Brief Description of Proposal:

To develop a total of 85 dwellings on a 1.4ha site with vehicle access via Compass Point Way and exit via Pigeon Mountain Rd.

5. MATTERS / ITEMS DISCUSSED AT MEETING

Figure 3 – Plan discussed at meeting

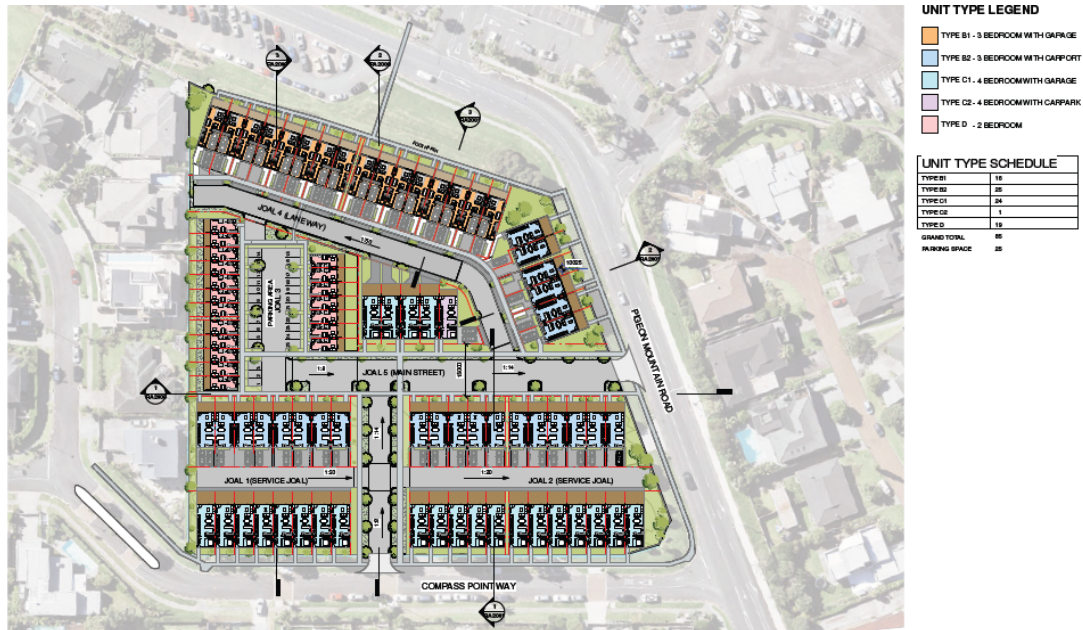
- The length of blocks required to achieve the desired yield through an MHS compliant terrace typology has resulted in large blocks which are at risk of being dominant masses despite architectural treatment.

- While an attempt has been made to break up the perceived dominance and intensity of the terrace blocks, these approx. 1m gaps are not effective at doing so and are not functional spaces.

- The interior of the site is dedicated to JOALs, carparking and private dwellings, with few opportunities for any significant sense of landscaped area and the spaciousness it brings. While fences have not been shown, this has the potential to further increase the sense of intensity within the site.

- The intensity of car manoeuvring and reversing across noted primary footpaths such as JOAL 4 is a significant concern.
- Site Amenity
 - The street fronting address and entry to units on Compass Point Way is commended – however with bedrooms at this street interface rather than a kitchen, there is little opportunity for activity and connection with street.

- The provision of safe and separated pedestrian access ways is encouraged.
 - While there is an apparent separated pedestrian path to all units, for many units this may be perceived as a rear entry and seldom used for this purpose. For example, mid-block terraces serviced by JOAL 1 and 2 may perceive and use the door facing these JOALs as their primary day-to-day entry, which provide no safe or separated pedestrian access. For units on

JOAL 4, the safe pedestrian access way is a rear entry formed on the public park.

- Regarding the dwellings on the western boundary of the site
 - Concerns for amenity in terms of sunlight are raised as retaining walls and existing neighbouring dwellings along the western boundary of the site are quite high in relation to the decks / 2-storey development on this side
- Changes to the roading network (shifting the road connecting to Compass Point Way to align with service JOAL 3)
- How much amenity does the client want to sell to the market?

- Pedestrian links, sightlines through the blocks, open space and common landscape amenity will be important to resolve in order to achieve a successful design.

- It is recommended that the Auckland Urban Design Panel would be of significant benefit to this application to achieve the most successful outcomes for the site, with the potential to support infringing MHS standards to achieve these.
